EYNESHAM PARISH COUNCIL

30 September 2022

Application No.	R3.0151/21
Proposal	<ul style="list-style-type: none">• The dualling of approximately 3.2km of the A40 carriageway from the existing Hill Farm junction at Witney to the Eynsham Park and Ride site (R3.0057/19) including the construction of two new roundabouts.• An eastbound and westbound bus lane approximately 6.5km in length from the Eynsham Park and Ride site to existing structures at Duke's Cut waterway (Duke's Cut Canal Bridge, Earl's Culvert, Wolvercote Railway Bridge and Wolvercote Canal Bridge);• Capacity and connectivity improvements over the existing structures at Duke's Cut waterway to enable the proposed eastbound bus lane to extend over the existing structures up to the A34 flyover in the east, forming a connection into Oxford North (Northern Gateway) strategic development site;• Construction of a new signalised junction to the Eynsham Park and Ride site;• New pedestrian/cyclist underpass at Cuckoo Lane ('the Eynsham Underpass').• Two new pedestrian/cycle bridges at Cassington Halt (Cassington Halt Footbridge North and Cassington Halt Footbridge South);• Widening of Cassington New Bridge;• Demolition and replace

Figure 1 – Land Use and Accessibility Baseline page 62 of Chapter 13 Population & Human Health Environmental Statement. Shows Public Rights of Way (Bridleways - pink, Footpaths - brown)

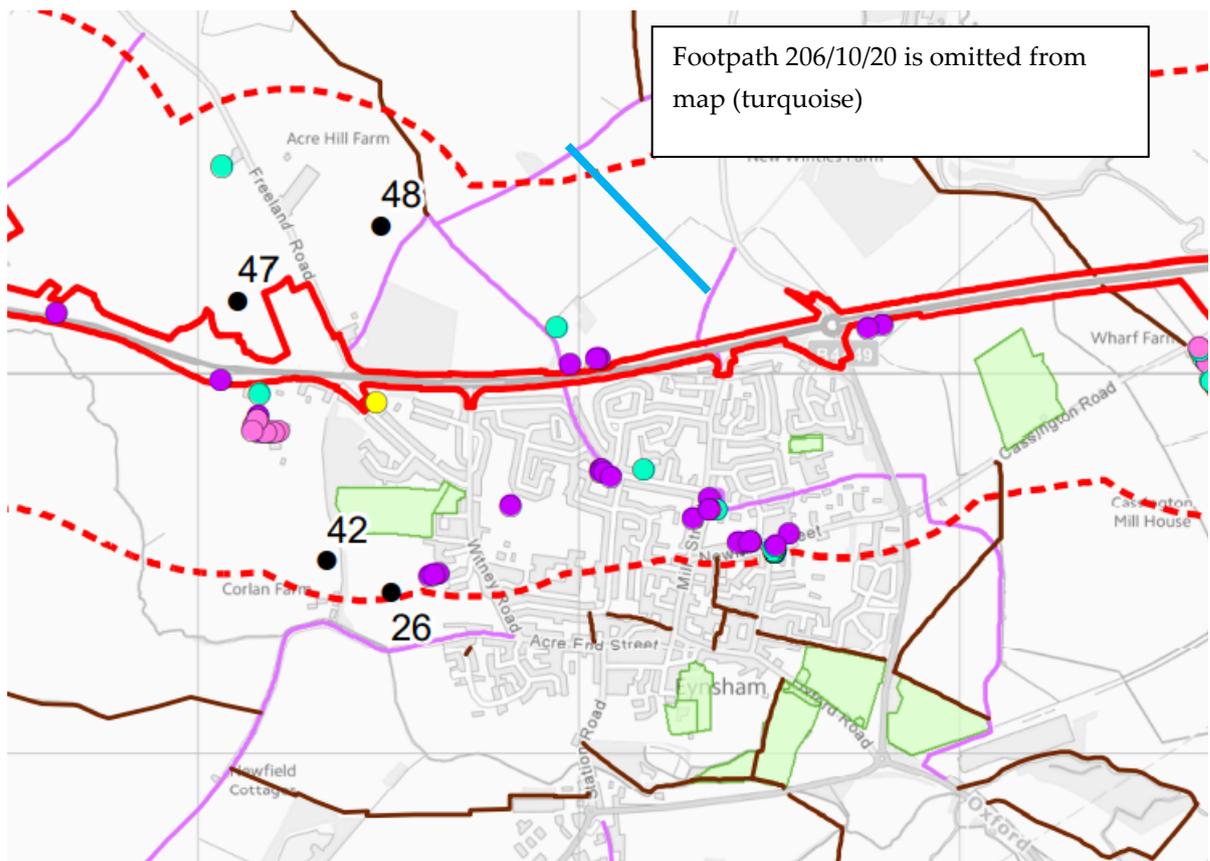
3.1 'Land Use and Accessibility Baseline' map at page 62 does not include or consider PROW 206/10/20 which is shown below in turquoise. Access to the countryside and green spaces in Eynsham is very limited³ and to note those north of the A40 will be closed for any length of time, is a significant concern to the community and will be strongly opposed. The ['Updated Chapter 17 Residual Effects and Mitigation'](#) document highlights the extent of planned exclusion from the countryside being imposed on the community which we strongly object to.
